68 Maids Causeway

Responses to objections

Glass blocks

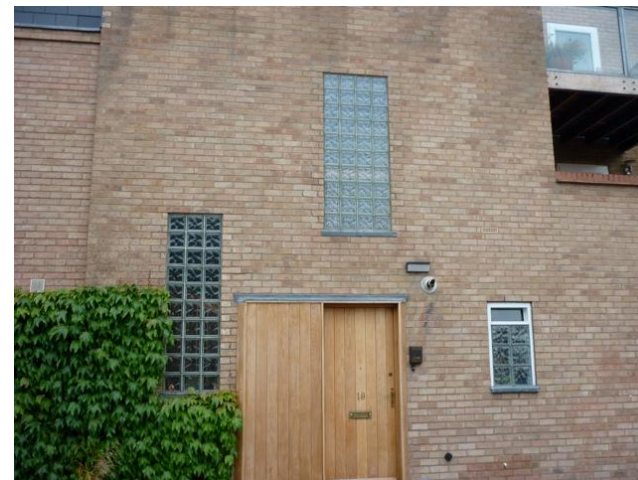
- ▶ The concern is that the proposed glass blocks
 - are inappropriate for this location, particularly on such a prominent wall that is visible in views down Maids Causeway.
 - will allow a negative feature to stand out further, as it is not in keeping with the character and appearance of the Conservation Area
- ▶ We have included the glass blocks partly to increase light into the proposed dining area and secondly because we believe they are a visual enhancement that improves the look of the walls.
- ▶ We note that there are several examples of the use of glass blocks in the area.
 - ▶ 19 North Terrace has extensive use of glass blocks, clearly visible from Midsummer common
 - ▶ Glass panes resembling glass blocks are used extensively in the Zebra pub adjacent
- ▶ Nevertheless, we are prepared to concede this feature if necessary

Velux windows

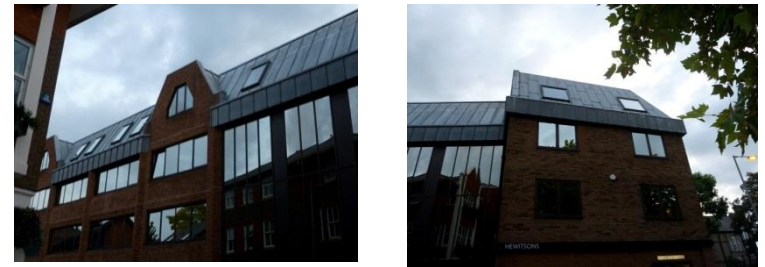
- ▶ With regard to rooflights, the statement is made in the conservation consultation that
 - types which stand proud of the plane of the roof (“velux”) are unlikely to be approved
- ▶ We note that there are numerous examples of such roof lights that stand proud of the plane of the roof on both older and newer properties on Maids Causeway, in Fitzroy lane and in other adjacent streets
- ▶ This comment appears inconsistent with the reality of existing practice in the area
- ▶ There are rooflights in the attic of the existing building and it would be incongruous to use a different style of “conservation” roof lights adjacent to these.
